## **Temporary Shoring Submittal April 14, 2014**

## Route 73 Bridge Project

Subject: Rochester ER BRF 0162(18) – Response to Comments – Temporary Shoring

**A** Typical Section  
Not to Scale

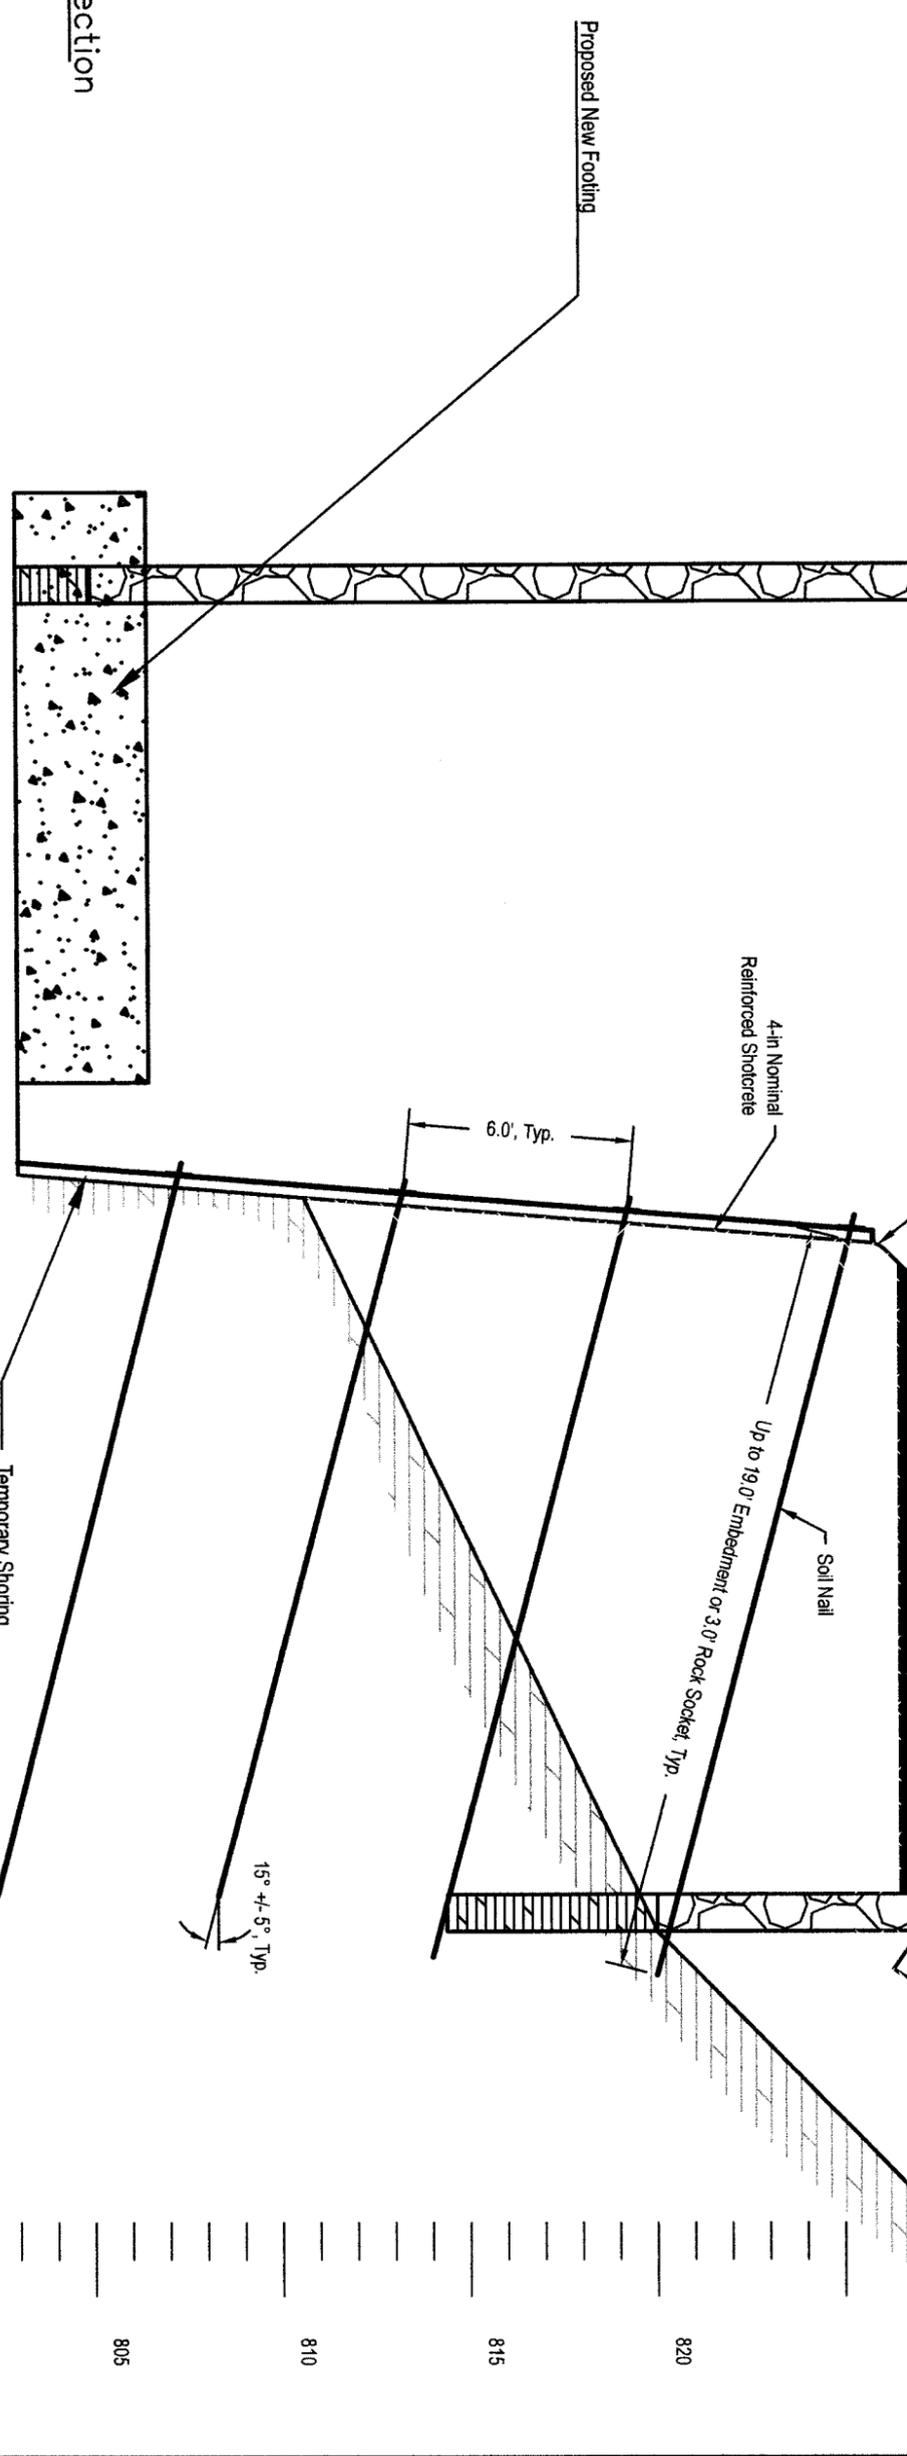
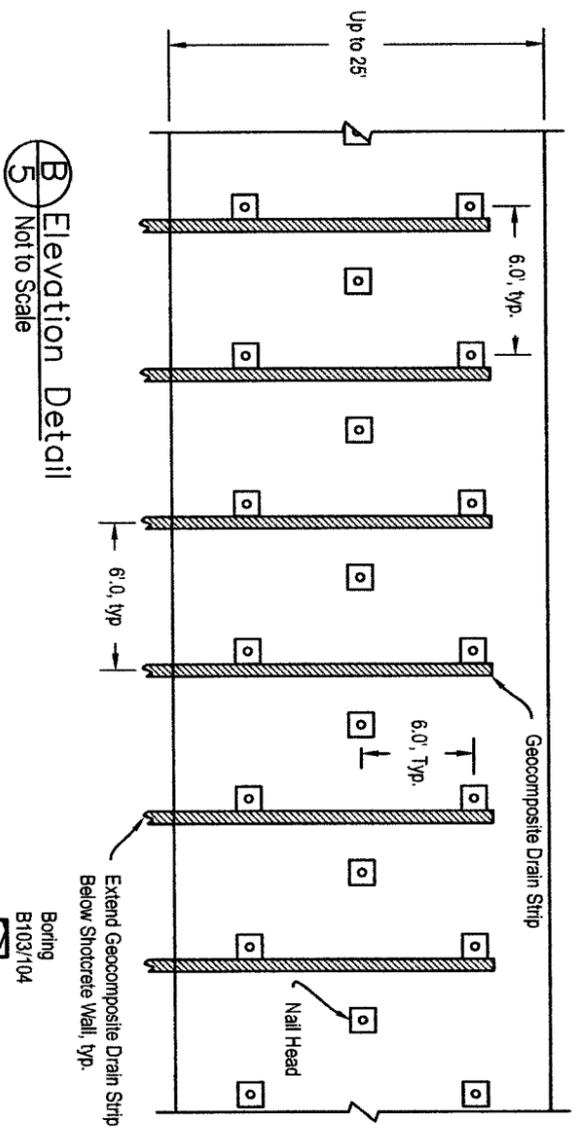
3. Additional loads have been placed on the temporary shoring structure to approximate reaction loads from the temporary bridge.
4. Calculations have been updated. Initial modelling used a surcharge load of 250 psf (equivalent of 2-ft of additional soil). The revised models shows a load equivalent to 2 feet of soil with an additional 2 feet of equivalent soil (total of 4 feet) to account for normal traffic loads, construction activities, and additional reaction loads from the temporary bridge.

**Test Nail Detail (With Shotcrete)**  
Not to Scale

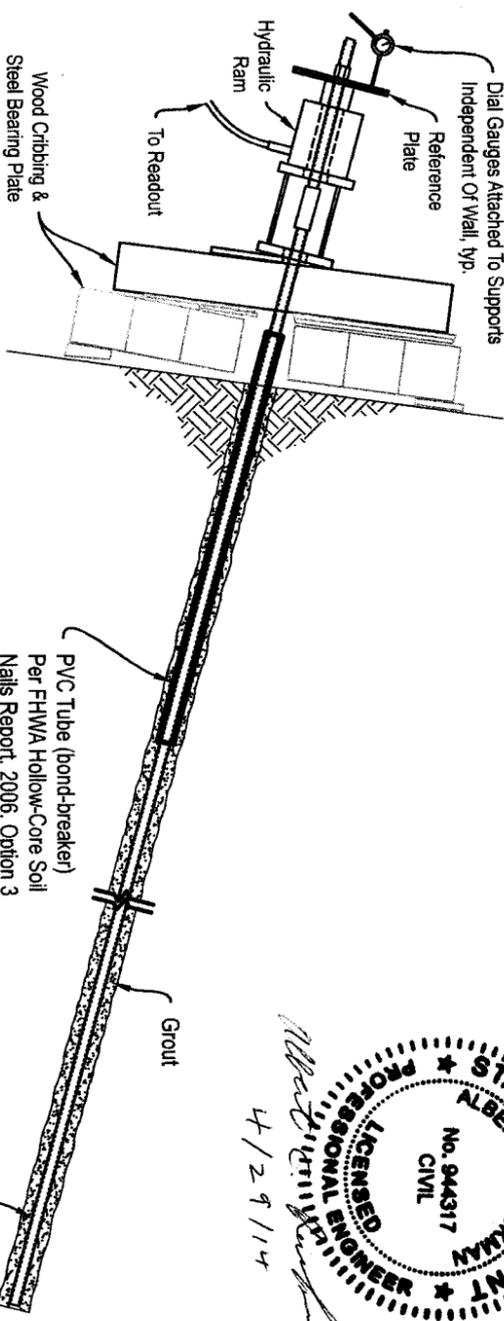
7. The design load has been incorporated in to the plan sheets.
8. The design plans have been updated to include a test nail sheet. A proof test will be conducted on one nail per row of production nails.

- Four (4) proof tests will be performed on production nails, one nail for each row, and test nails will be tested 72 hours after installation. Proof testing may be conducted before 72 hours provided that the Contractor submits qualified independent test data demonstrating that the grout mix has reached its minimum 3-day compressive strength.
